# Transmission Expansion Advisory Committee DEOK Supplemental Projects

## DEOK Transmission Zone M-3 Process Turfway

**S3600.1:** will be posted in 2025 Local Plan. Need Number: DEOK-2024-004. Original Solution Meeting on 02/14/2025.

**Supplemental Project ID:** s3600.1

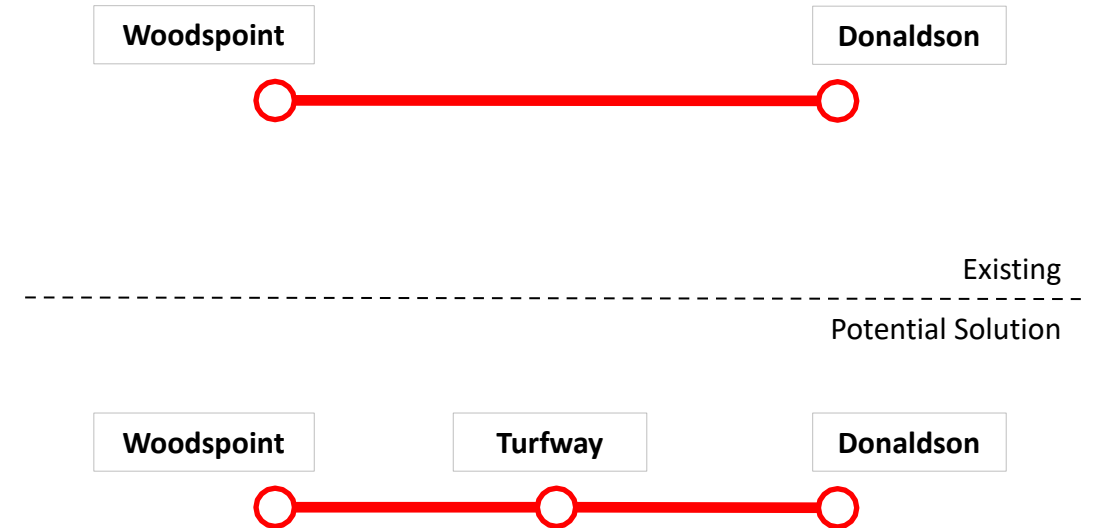
The planned new 138 kV Turfway substation is being changed from a straight bus to 4-breaker ring bus to improve reliability and operational functionality of the substation.

Build a new substation, Turfway, with a ~~switch connected straight bus configuration, two circuit switcher connected~~ 4-breaker ring bus with nonadjacent feeders supplying two 138/34 kV, 22.5 MVA transformers with two distribution exits each.

**Estimated Transmission Cost:** ~~\$13M~~ \$15.8M

**Proposed In-Service Date:** ~~07/25/2029~~ 07/26/2028
